Access Compliance Report

Public Rights-of-Way

(Curb Ramps)

Intersection ID: 30075	Main Street: SOUTHWIND_DR	Cross Street: WOODLANDS_POINTE_DR	Location: W
ADA ID: 85E944A33602	Ramp Type: PerpDiag	Initial Pass/Fail: Pass	Overall Compliance: No
		Severity Score: 0.25

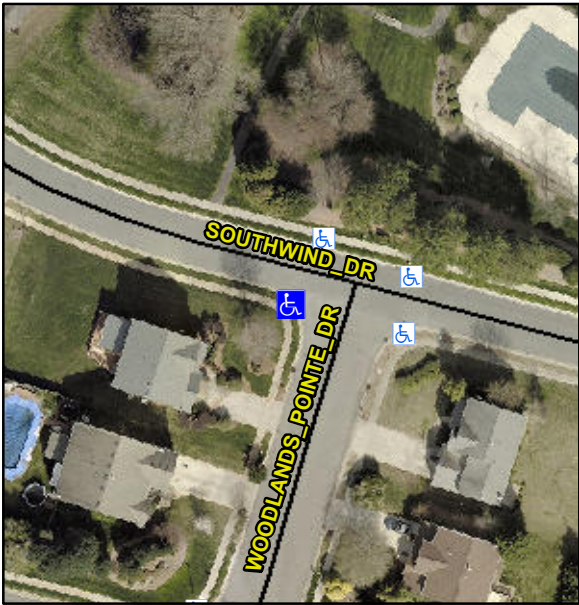
Codes/Mitigation Info/Possible Solution			Field Measurements/Component Compliance																	
	Possible Solutions:		Remove & Replace Curb Ramp With Two New Directional Ramps or Equivalent.																	
	Surveyor Notes:		N/A																	
	PROW/ADA:		Not Found, R304.5.3, R304.2.1, R305.2																	
	Street 1 Name		WOODLANDS POINTE DR																	
	Stop Condition-Street 2		StopSign																	
	Street 2 Name		SOUTHWIND DR																	
	Stop Condition-Street 1		None																	
	Total Cost:		\$ 3200.00																	
			Compliance			Description			Data			Compliance			Description			Data		
			N/A			Ramp Length (in)			52.0			Yes			Ramp Slope (%)			6.7		
			Yes			Ramp Width (in)			48.0			No			Ramp XSlope (%)			2.2		
			N/A			Flare Type LT			Sloped			N/A			Flare Type RT			N/A		
			N/A			Flare Slope LT (%)			4.7			Yes			Flare Slope RT (%)			2.8		
			N/A			Flare Traversable LT?			Yes			N/A			Flare Traversable RT?			Yes

No			Landing Length (in)			41.0			Yes			DWS Provided?			Yes		
			Yes			Landing Width (in)			48.0			Yes			DWS Contrast?			Yes		
			Yes			Landing Slope (%)			1.7			Yes			DWS Length (in)			24.0		
			Yes			Landing X Slope (%)			2.0			Yes			DWS Full Width?			Yes		
			N/A			Landing Curb? (Y/N)			No			No			DWS Offset (in)			3.0		
			N/A			Shared Landing?			No											
			Yes			Gutter Ponding?			No			Yes			Gutter Slope (%)			1.2		
			Yes			Gutter Lip Ht (in)			0.0			Yes			Gutter X Slope (%)			1.1		
			N/A			Painted X Walk1?			No			N/A			Painted X Walk2?			No		
						X Walk 1 Direction			To SE						X Walk 2 Direction			To NE		
			N/A			X Walk 1 Width (in)			N/A			N/A			X Walk 2 Width (in)			N/A		
						X Walk 1 Slope (%)			4.2						X Walk 2 Slope (%)			4.0		
						X Walk 1 X Slope (%)			0.0						X Walk 2 X Slope (%)			1.5		
			N/A			Ramp inside XWalk1?			N/A			N/A			Ramp inside XWalk2?			N/A		
						Road Slope (%)			1.3			N/A			Clear Space?			Yes

Road X Slope (%)			3.5			N/A			Clear Space to XWalk (in)			N/A		
			Yes			Any Obstructions?			No			Yes			Storm Grate/Utility Hazard?			No		
						Obstruction Type									Storm Grate/Utility Type					
												N/A						N/A		
												Yes			Surface Condition? (G/P)			Good
